Recall Bulletin 70702

**RECALL
BULLETIN:
70702**

SUBJECT:
Class C Steel
Spare Wheel
and Tire
Replacement

ISSUE DATE:
May 2008

Figure 1

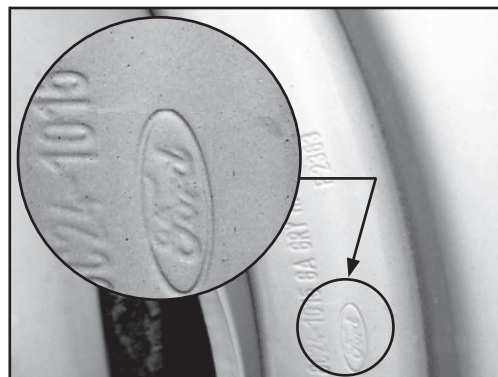
1. Locate and examine the spare wheel with tire.
 - (A) If the spare wheel has 8 hand holds, no further action is necessary.
 - (B) If the spare wheel has 4 hand holds, proceed to Step 2.
2. Look for the “FORD” logo stamped into the valve-stem side of the spare wheel, approximately 180° from the valve stem. (See Figure 1.)

Ford wheels are not affected by this Recall.

Figure 3

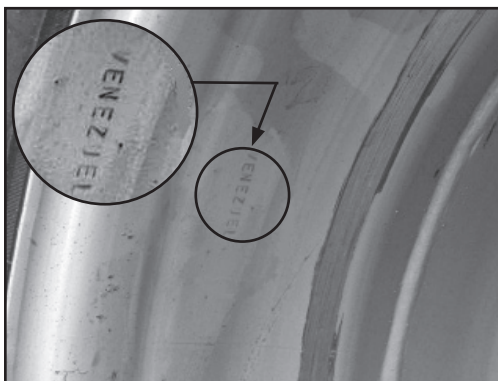
- If the “FORD” logo is found on the spare wheel, contact Fleetwood Dealer Technical Support for authorization to inspect the additional wheels, as it is possible that the spare may have been previously mounted on an axle during a previous repair.
- If the “FORD” logo is not present on the valve-stem side of the wheel, check the opposite side for a stamping. Wheels marked either “CHINA” or “VENEZUELA” must be replaced with a new wheel and tire, part #535995 (includes wheel with mounted tire). See Figures 2 and 3.

Wheels marked “VENEZUELA” must be replaced according to this Recall.

3. Advise the customer not to use the spare wheel and tire until replaced.
4. Order the replacement spare wheel and tire, Part # 535995.
5. Return the defective wheel with tire to Fleetwood for warranty claim processing.
